**TRANSMITTAL OF THE SITE EVALUATION REPORT FOR ADDENDUM 2 SOIL
PILES AT THE PADUCAH GASEOUS DIFFUSION PLANT, PADUCAH, KENTUCKY
(DOE/LX/07-0188&D2/R1)**

Document Identification: *Site Evaluation Report for Addendum 2 Soil Piles at the Paducah Gaseous Diffusion Plant, Paducah, Kentucky, DOE/LX/07-0188&D2/R1*

**Site Evaluation Report
for Addendum 2 Soil Piles
at the Paducah Gaseous Diffusion Plant,
Paducah, Kentucky**

Figure B.23. Comparison between Cesium-137 Concentrations in Samples from Soil Piles Addendum 2 and Surface Soil Background Concentrations

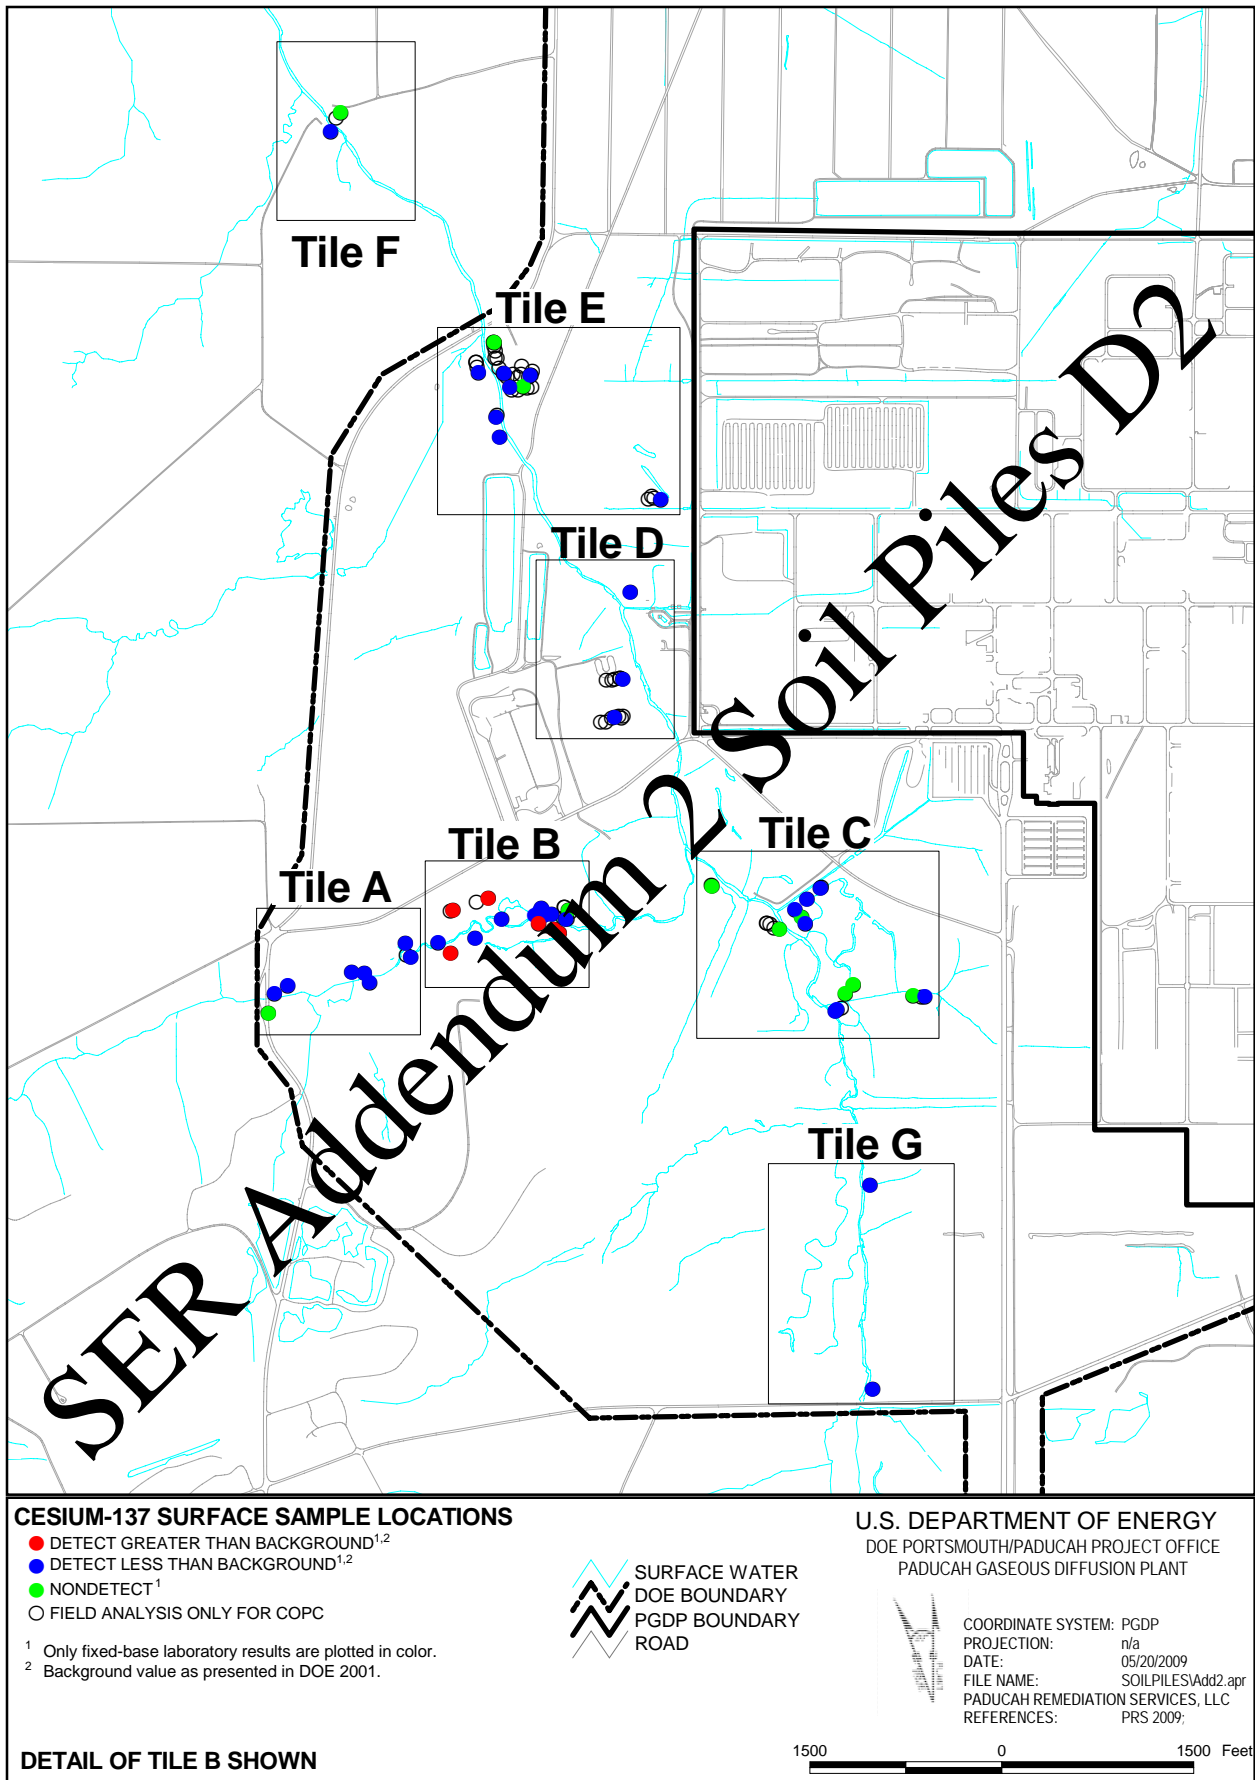
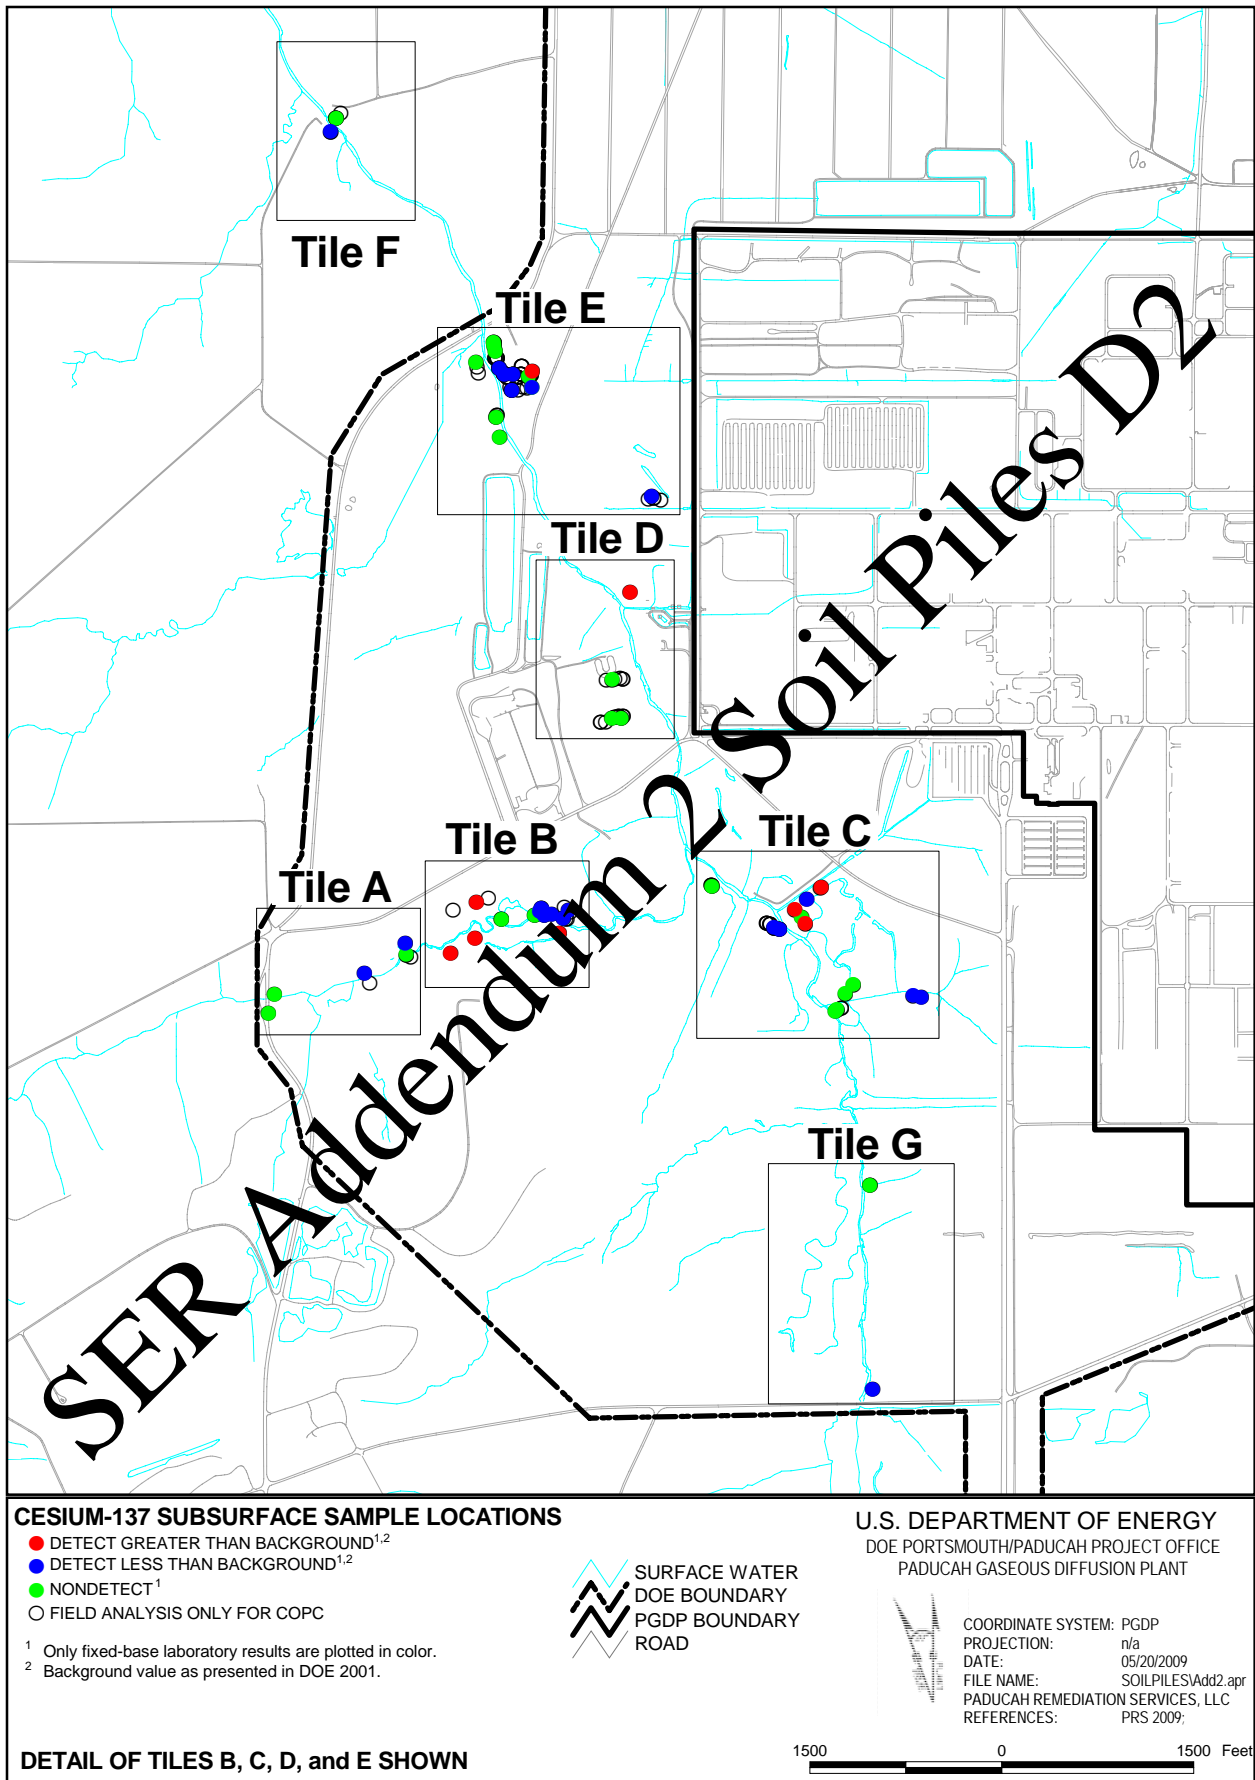
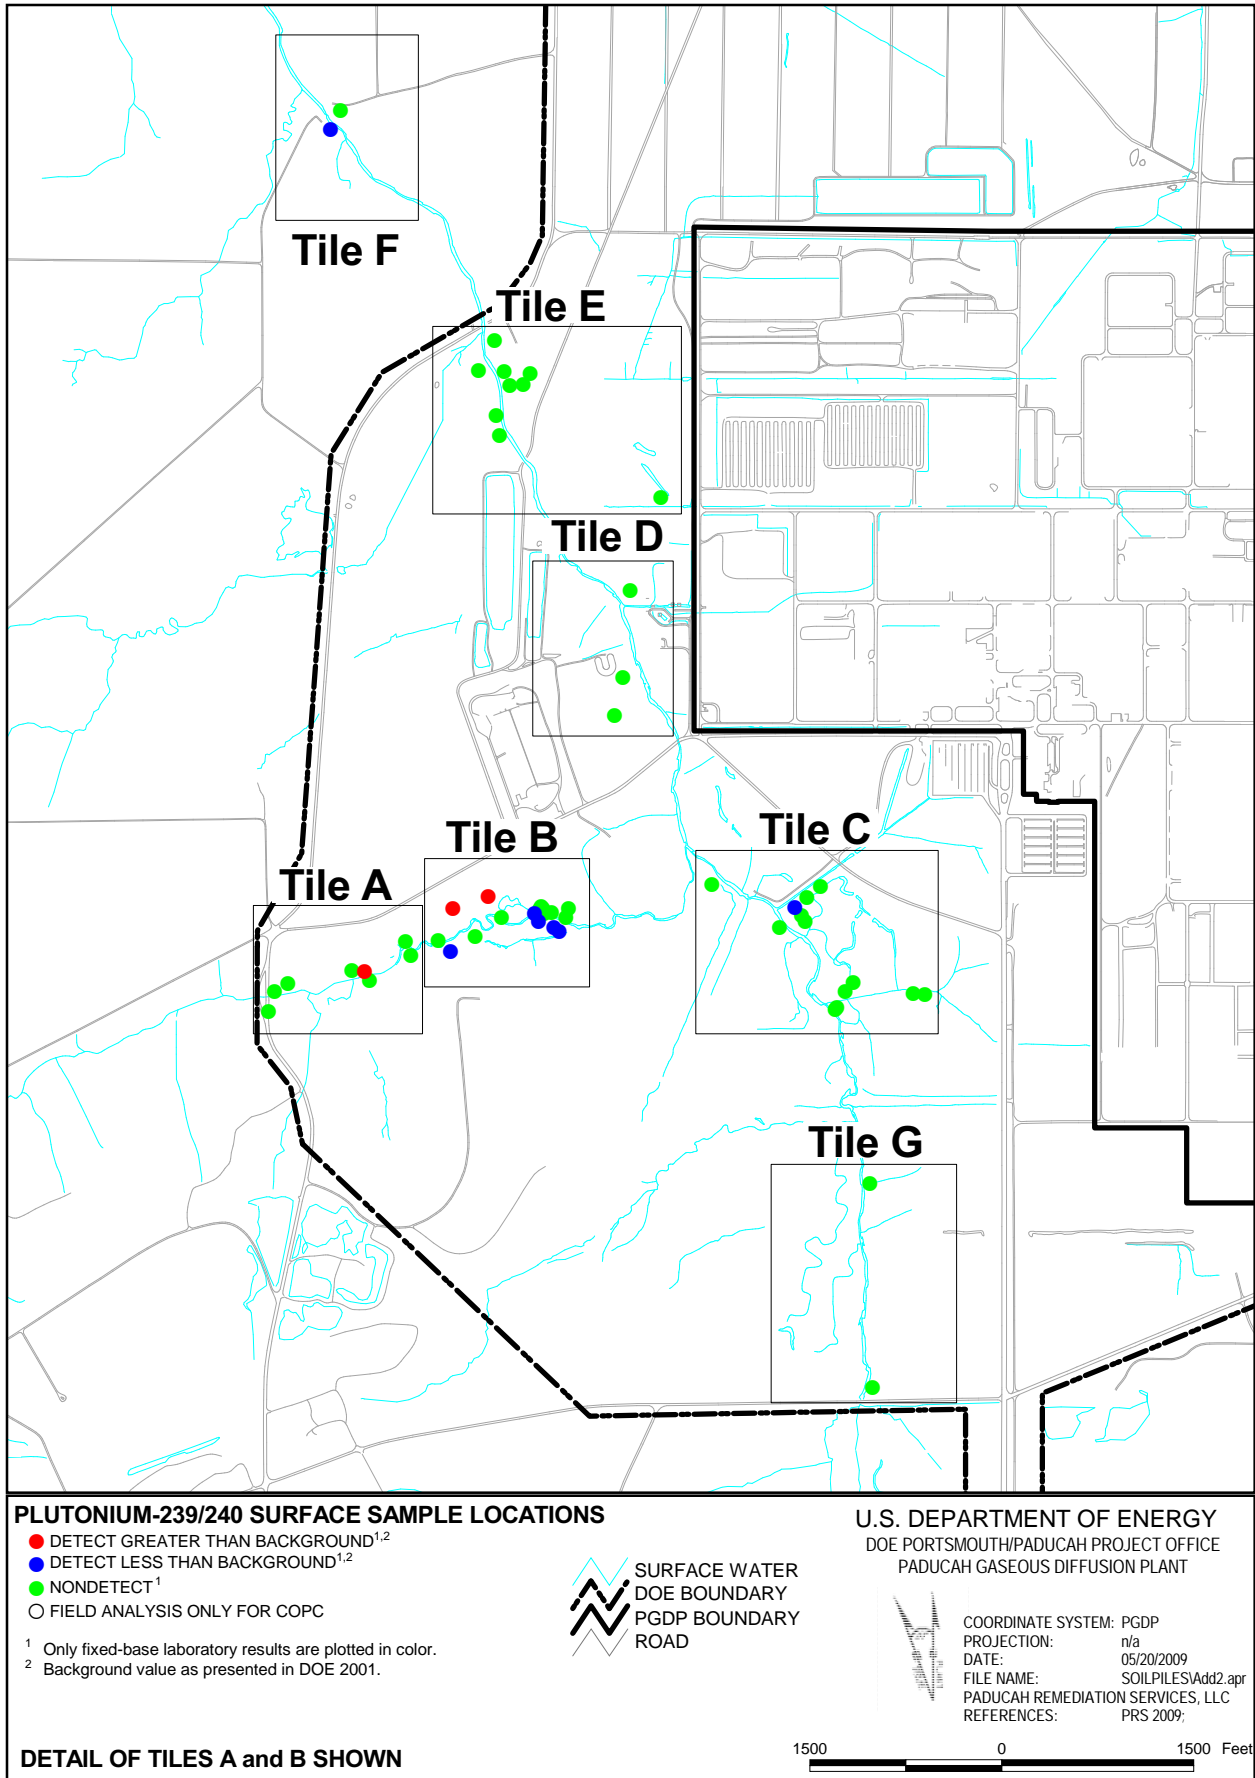
Comment Number	§/Page/¶	Comment	Response
14.	Appendix B, Figure B.23 – page B-48, B.26 – page B-52 and B.28 – page B-58	The reference to soil background concentrations from the “(DOE 2008)” is incorrect. The reference in the chart to “DOE 2008” has not changed. The only approved reference is the “(DOE 2001)”. The value charted is twice the median or mean from the draft Risk Methods Document (DOE 2010?) It would be best to provide a short paragraph stating that the value on the chart represented as DOE 2008 represents is twice the median or twice the mean from DOE Paducah background project documents. One of the background project documents is 1995 and another is 1997. A third document exists which you may also need to be cited. It will not be necessary to change the charts.	<p>References to DOE 2008 has been revised to DOE 2009. This document has been formally submitted as <i>Methods for Conducting Risk Assessments and Risk Evaluations at the Paducah Gaseous Diffusion Plant Paducah, Kentucky, Volume 1. Human Health, DOE/LX/07-0107&D1/V1.</i></p> <p>The text “the revised site background values for PGDP published for review in 2009”¹ has been added to the paragraph on page B-4 describing sources for screening values.</p> <p>The background project documents are not referenced because their information is incorporated into the DOE 2009 reference.</p> <p>¹ The draft site background values published for review in 2009 represent two times the log-transformed median (mean for radionuclides) value for use in screening to determine if inorganic chemicals or radionuclides are detected at naturally occurring concentrations in surface or subsurface soil.</p>

Figure B.27. Location of Sample Stations in Addendum 2 Soil Pile Sampling for Cesium-137 in the Subsurface

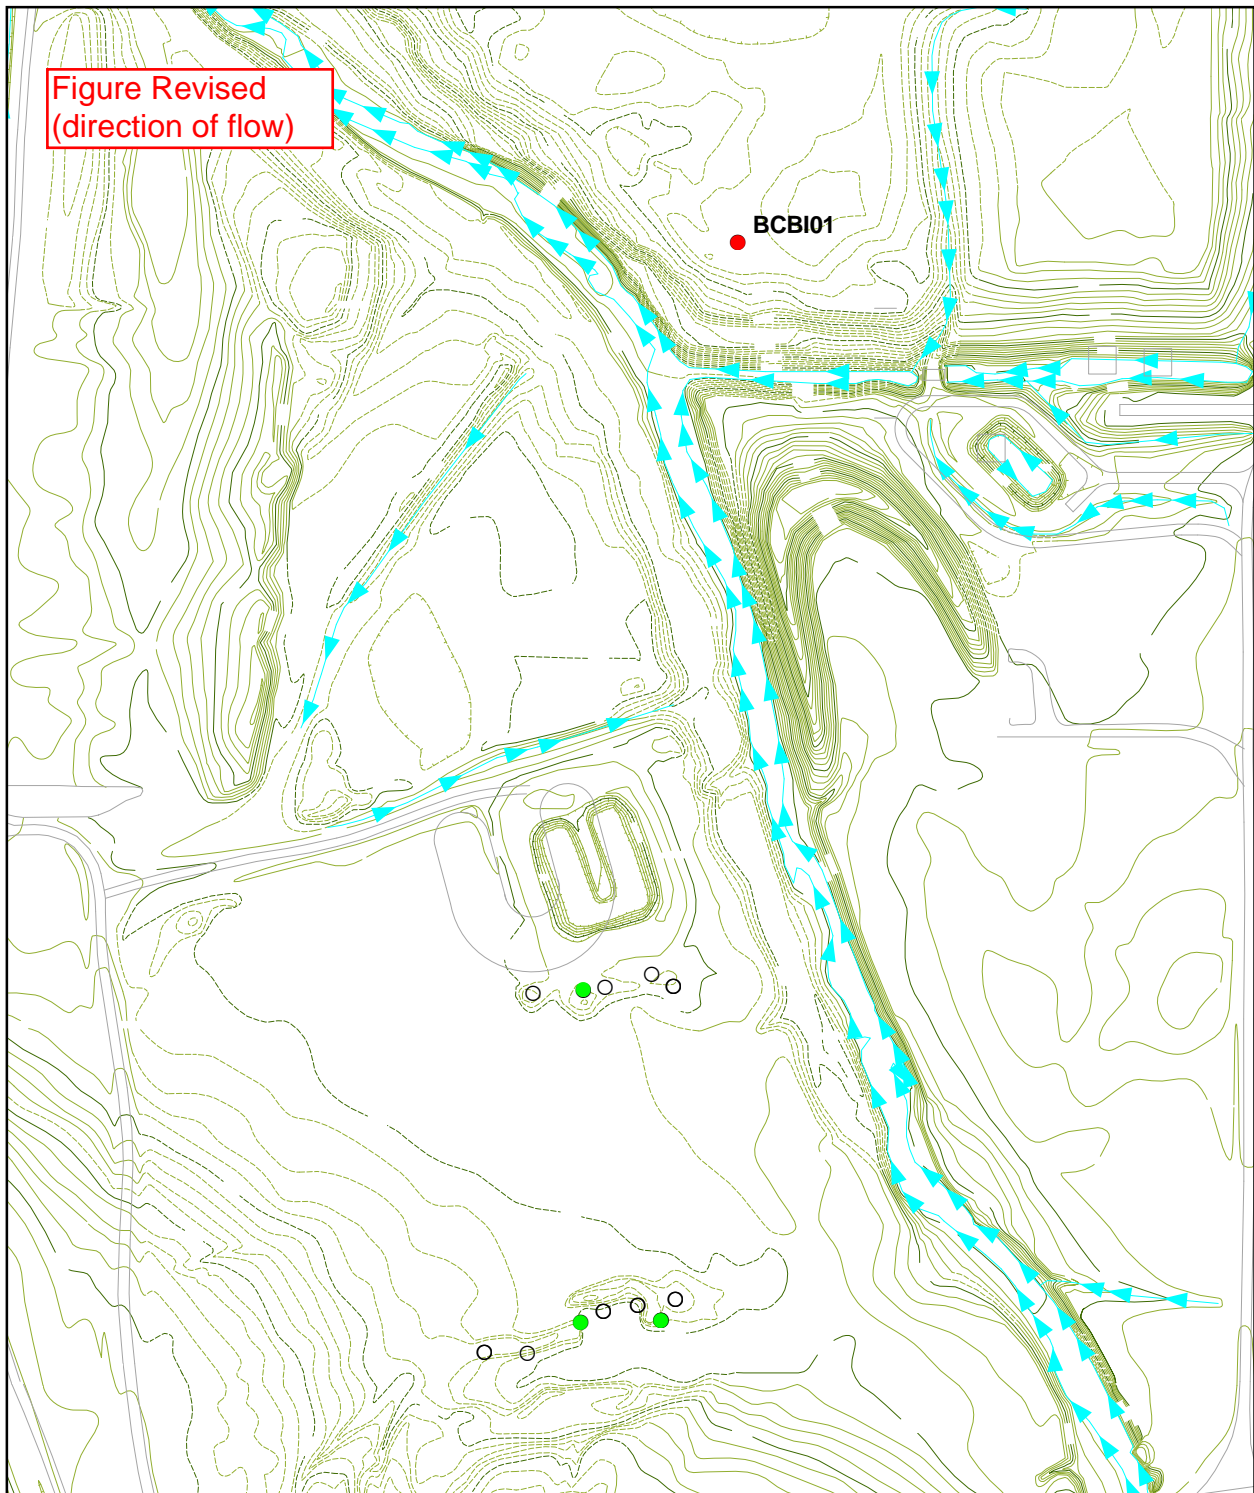
Figure Revised
(direction of flow)
